HISTORIC DISTRICT COMMISSION NOTICE OF DENIAL

Application Number: HDC2025-00753

PROJECT ADDRESS: 1616 W. Chicago Blvd Detroit, MI

HISTORIC DISTRICT: Boston-Edison

NEW REAR DECK PLAN ALL VIEWS
 ELVARDO MORALES
 1616 W. CHICAGO DETROIT, MI 48206

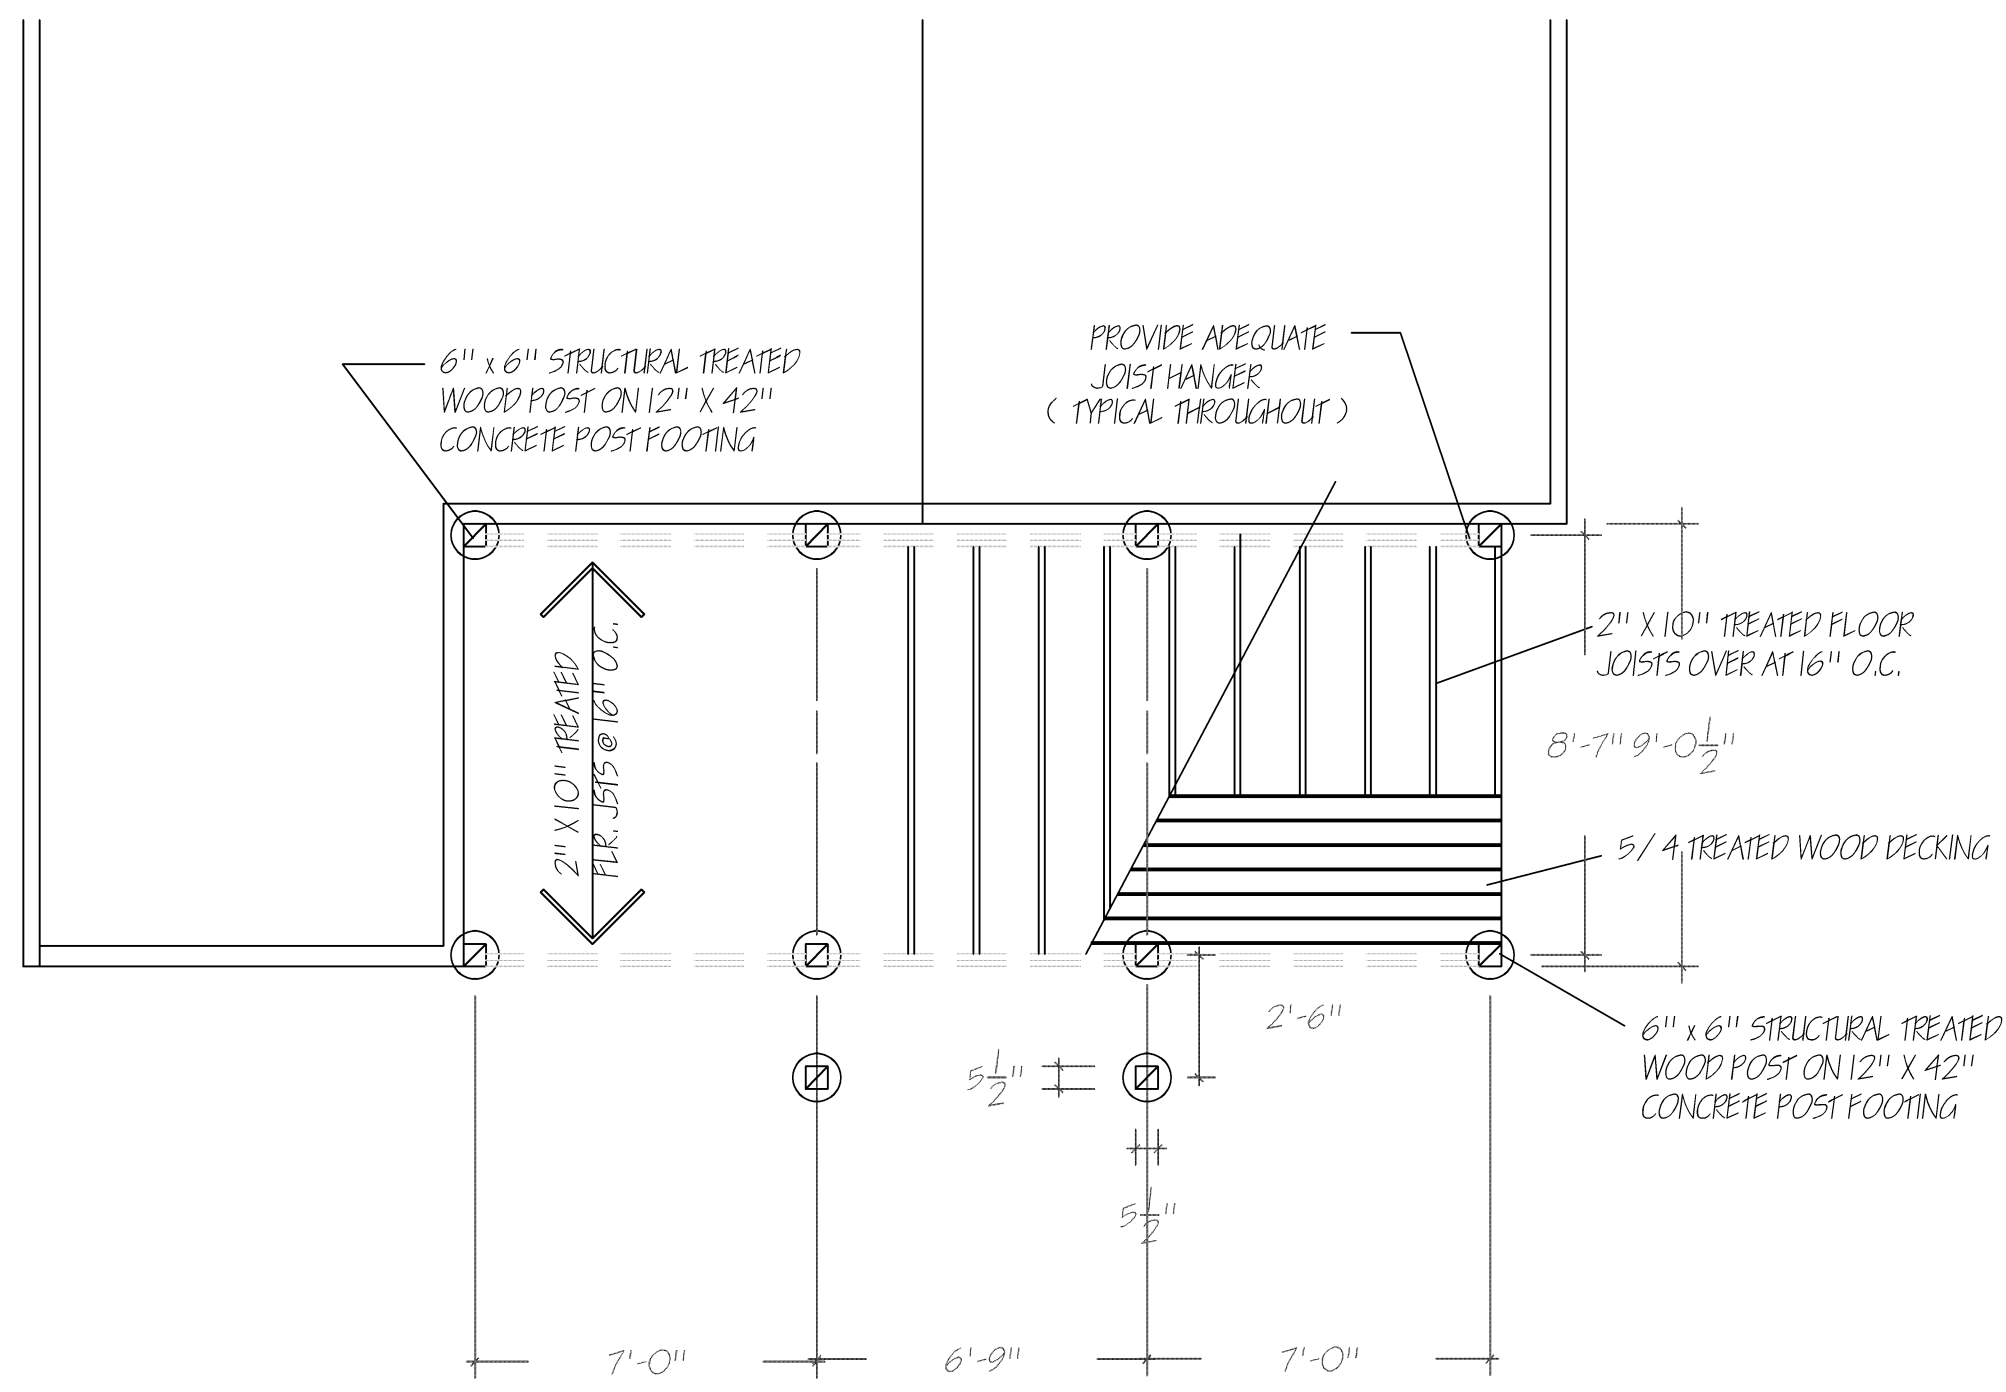
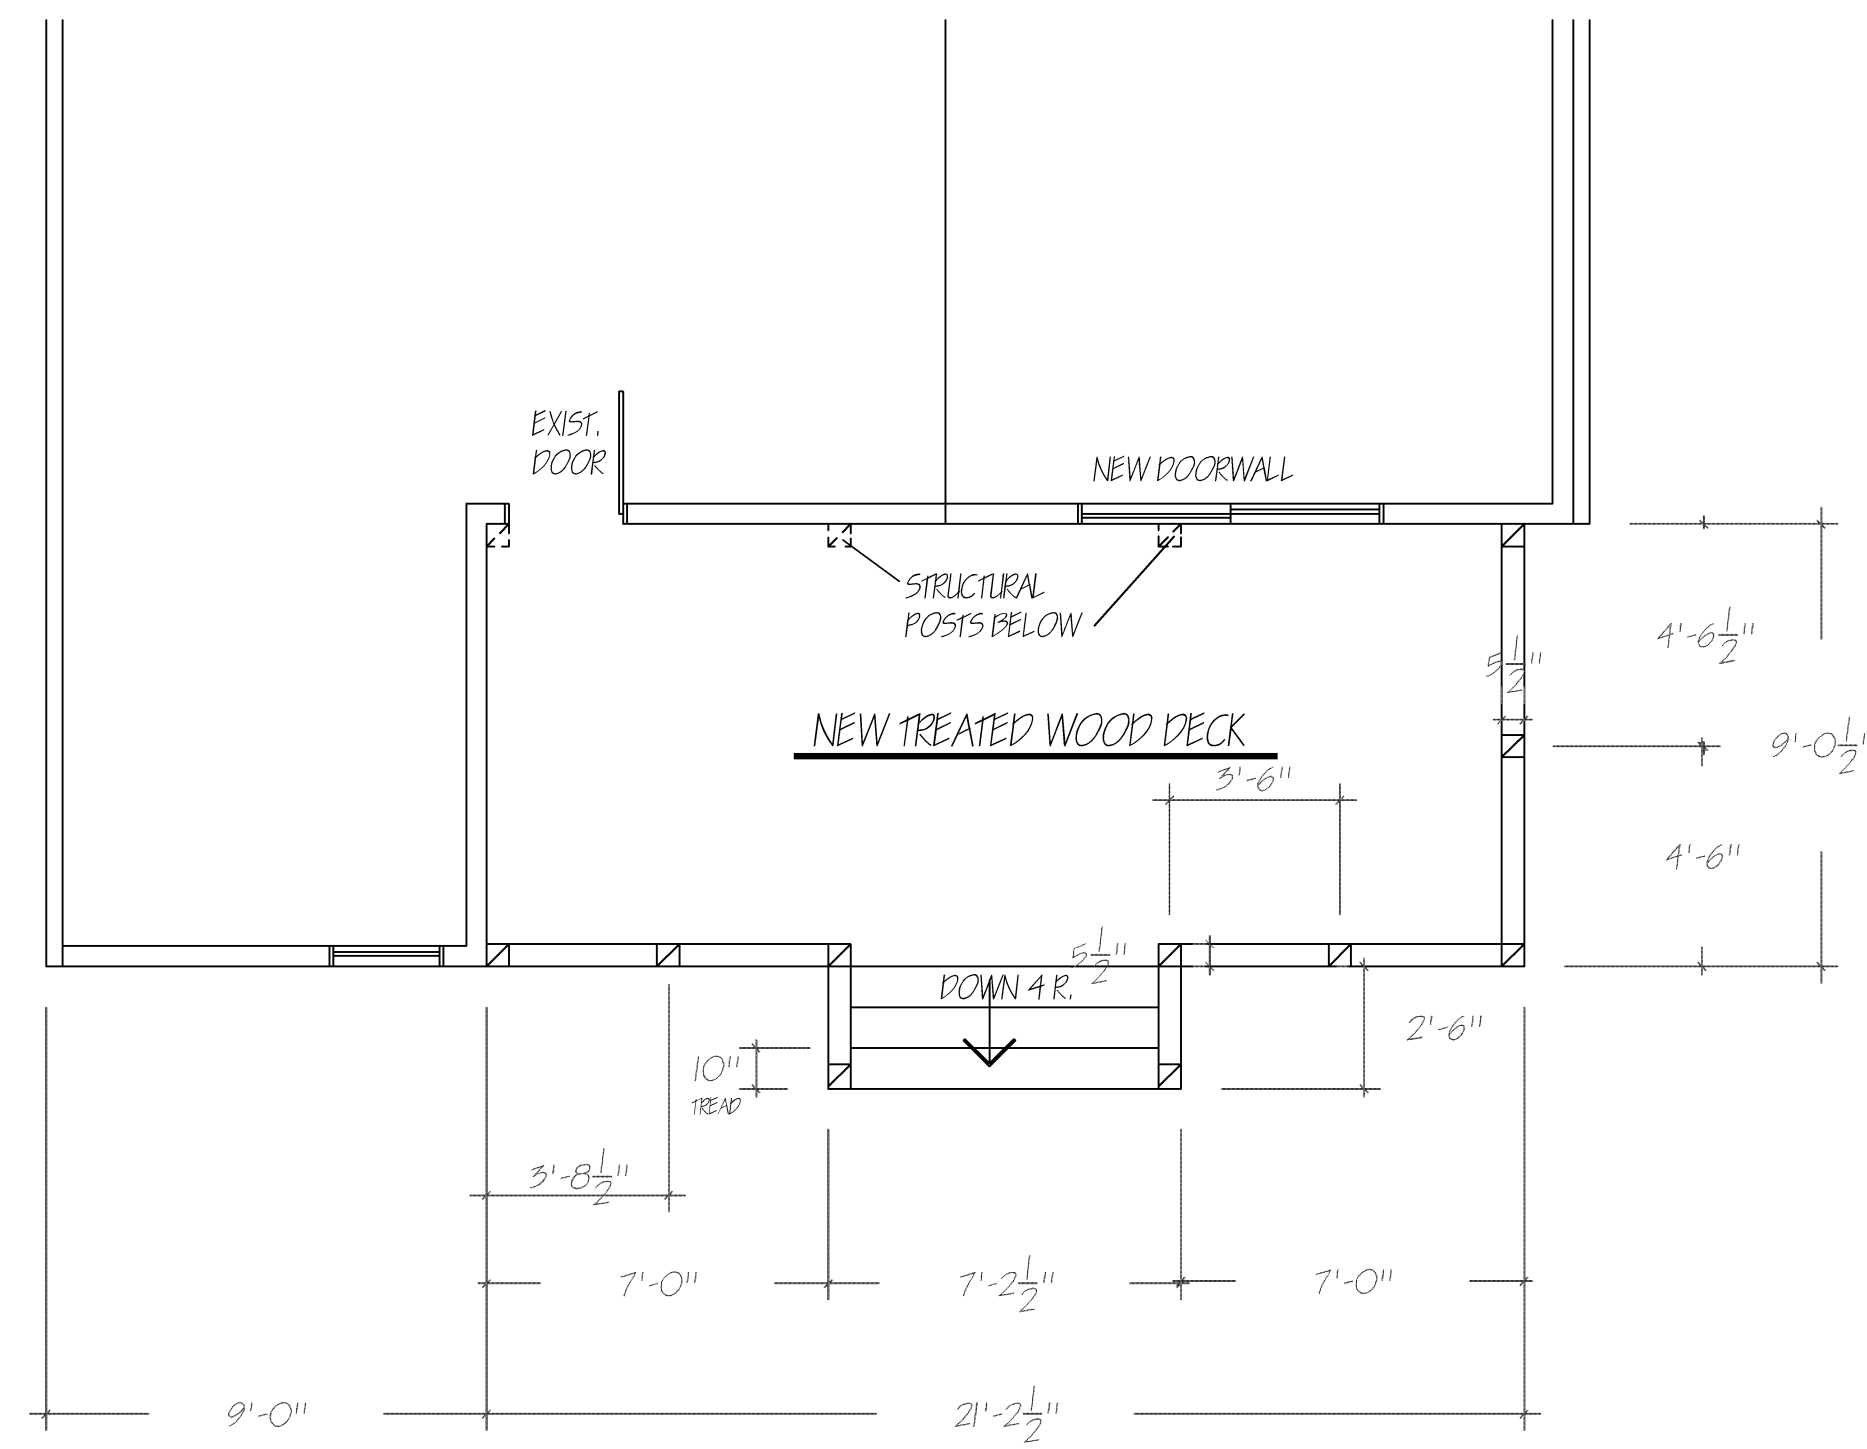
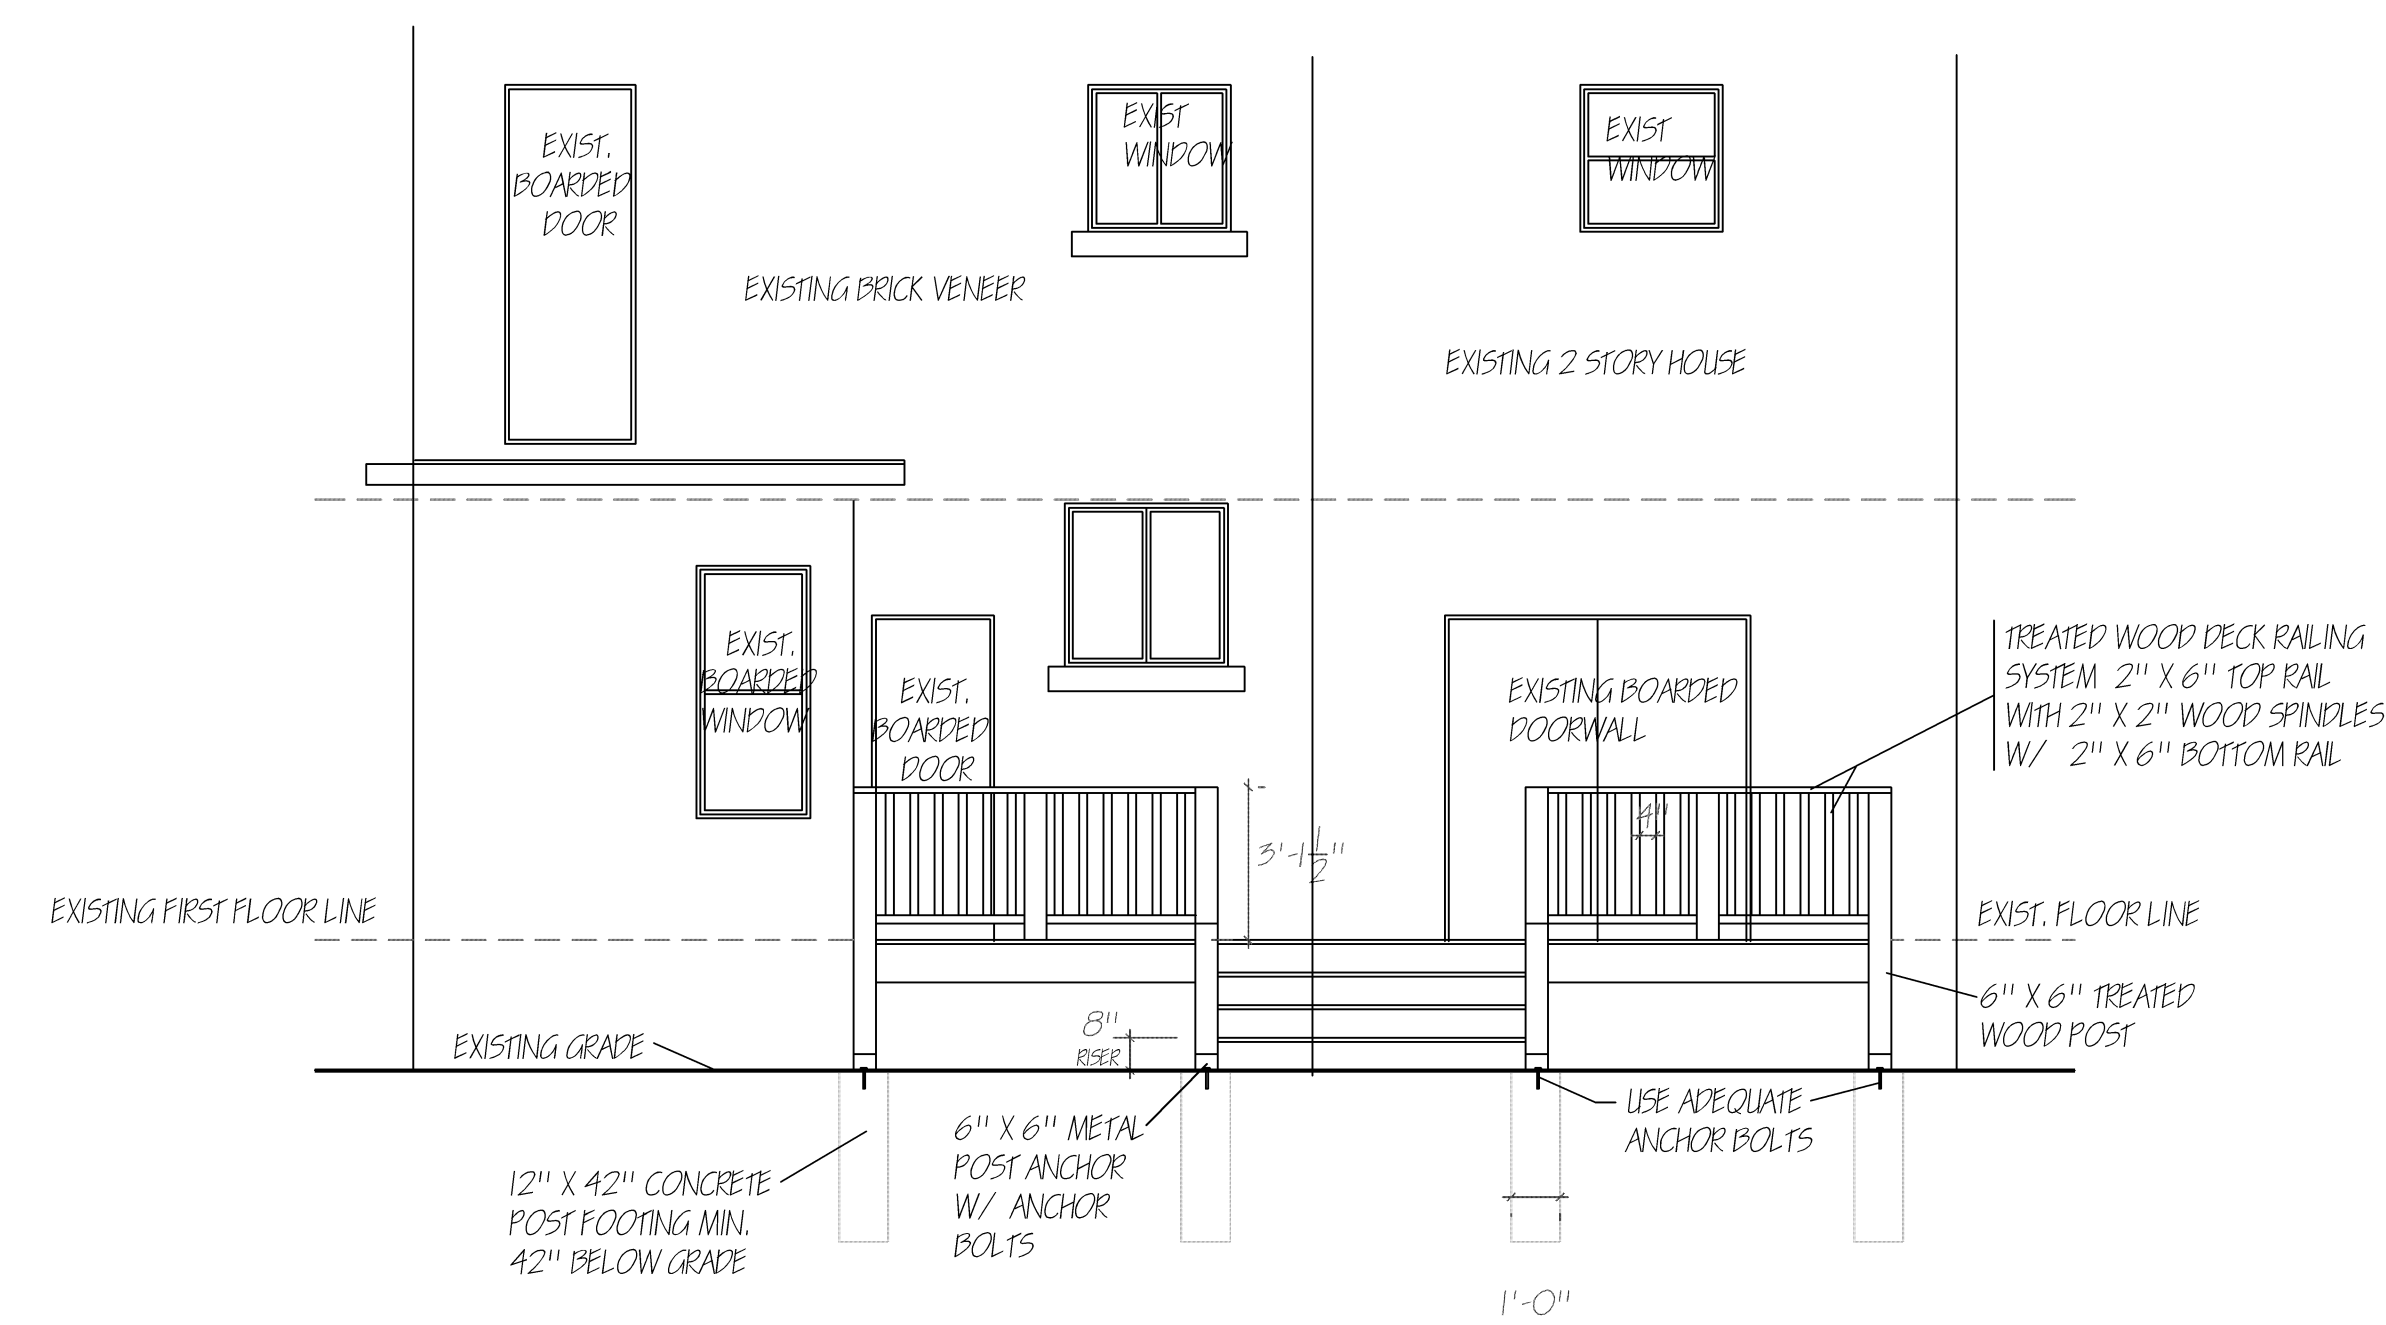
The proposed rear deck shall not extend into the footprint of the former two-story rear sunroom wing. The new design shall be submitted to staff prior to the issuance of the permit for review and approval.

REAR DECK

- Dimensioned elevation and site plan drawings with material call-outs

I have provided additional photos of the exterior of the house. We are no longer going to change any of the existing entry doors. The existing front porch slab will not be removed. We will fill in the cracks and repair the broken areas on the front of the slab. We have added a Site plan and elevations of the proposed rear deck. The site plan also shows the location of the proposed rear wood privacy fence. We will paint it within 1 year. We will not be doing anything to the dormers. I have found and attached pictures of the 2 story rear dormer before it was demolished. The siding appears to have been a stucco type covering. I'm sorry. I don't have any specifications of the siding that was on the demolished 2 story rear wing.
